TOWN OF UNDERHILL

Development Review Board

TIMOTHY & THERESA POTVIN
PRELIMINARY & FINAL SUBDIVISION REVIEW
Docket #: DRB-20-01

Project Proposal:	Preliminary & Final Subdivision Review of Timothy & Theresa Potvin for a proposed 2-Lot Subdivision of property located at the aforementioned address.
--------------------------	--

SECTION 3.17 – SOURCE PROTECTION AREAS

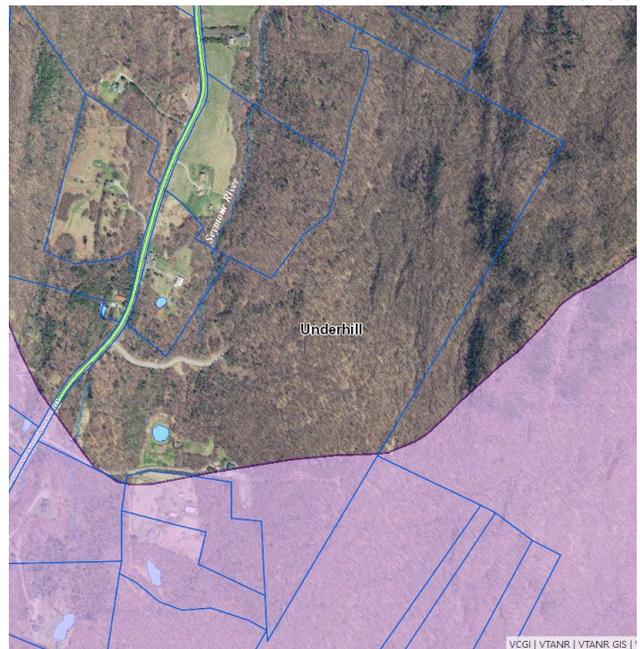
- Both proposed lots will contains areas designated as a Groundwater Source Protection Area; however, since the development already exists, and no new development is being proposed as a direct result of this subdivision application, review under this section appears to be unnecessary at this time.

SECTION 3.18 – STEEP SLOPES

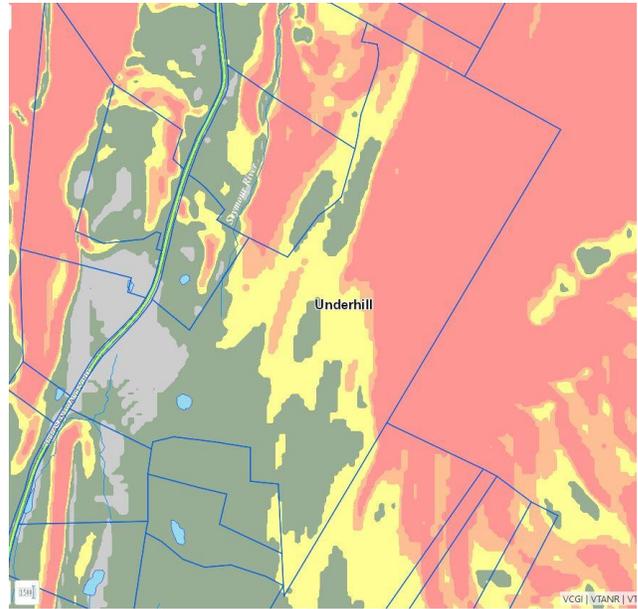
- Areas of steep slopes (15-25%) are present on the existing lot – 145 Moose Run (see directly to the right).
 - The existing development (the single-family dwelling that will remain on the “Portion of Lot 1” 2 and the accessory dwelling that will remain on Lot 5) appear to be located in areas that do not contain areas of Steep Slopes (15-25%) or very steep slopes.
- Since the development already exists, and no new development is being proposed as a direct result of this subdivision application, review under this section appears to be unnecessary at this time.

SECTION 3.19 – SURFACE WATERS & WETLANDS

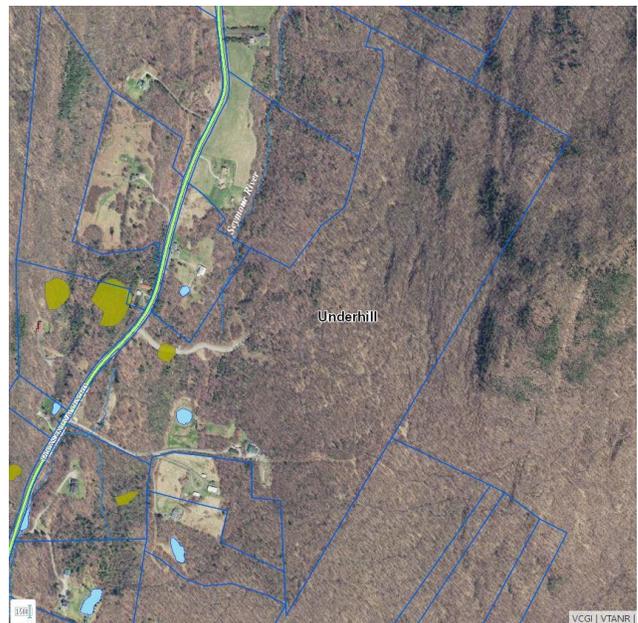
- An unnamed stream exists on the proposed Lot 5, and is depicted on the 2017 Survey (Exhibit N) submitted as part of a boundary line adjustment application (BLA-17-02).

- The Applicants resubmitted a site plan (Exhibit O) from their previous 2018 hearing with some modifications; however, that site plan did not depict the unnamed stream.

- Class II and Class III Wetlands were identified on the engineering plans (Exhibit N) from when the Applicants previously submitted a survey for a previously approved boundary line adjustment application in 2017 (BLA-17-02)

- The Applicants resubmitted a site plan (Exhibit O) from their previous 2018 hearing with some modifications, which includes the identification of a wetlands and wetlands buffer.

- Staff is unaware when this depicted wetlands delineation on the submitted site plan was performed, which would verify the delineation’s validity.
- Since the development already exists, and no new development is being proposed as a direct result of this subdivision, the Board should determine how much more review they want to conduct under this section.
